Date Issued :	April 01, 2022	PCN Number :	511407
Reason for Change :	Capacity change or tool replacement		
Description of Change :	Current tooling will be EOL in 2022 and increase capacity output per customers' request. Need new tooling to support		
Reason for Short Notice :	Capacity Increase		
Assessment of Change :	Reliability Test Report/s		
Planned Implementation Date :	July 15, 2022		
Sample Availability Date:	March 01, 2022		
Internal Molex Qualification Date :	March 01, 2022		
Last date to request Samples by Customer :	May 02, 2022		
Traceability Code Markings / Date :	Date code

Overview

Before Picture

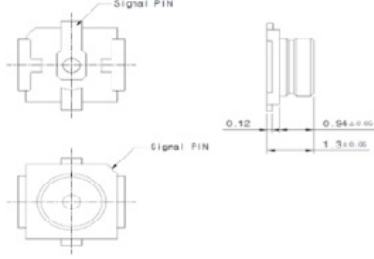
<ul style="list-style-type: none"> #1: PIN shape change #2: Height decrease #3: Signal direction in reverse #4: R shape added 		<ul style="list-style-type: none"> #5: Dimension of Insulator+BODY decrease(-0.04) #6: CMU total height decrease(-0.05) #9: Partial plating applied from the entire plating

After Picture

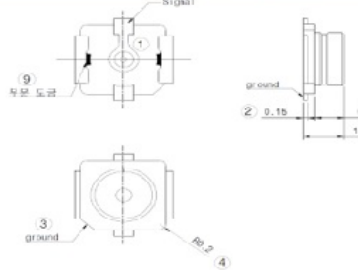
As-is Before	To-be After
BODY	<ul style="list-style-type: none"> · Material : Phosphor Bronze (C5210), 0.12t · Plating <ul style="list-style-type: none"> - Plating : Ni (More than 1~4um) - Final plating: Au (Flash) 	<ul style="list-style-type: none"> · Material : Phosphor Bronze (C5191) , 0.15t · Plating <ul style="list-style-type: none"> - Plating : Ni (More than 1um) - Final plating : Au (flash)
Insulator	<ul style="list-style-type: none"> · Material : LCP GA130 · Color : Natural 	<ul style="list-style-type: none"> · Material : LCP E6808 UHF · Color : White
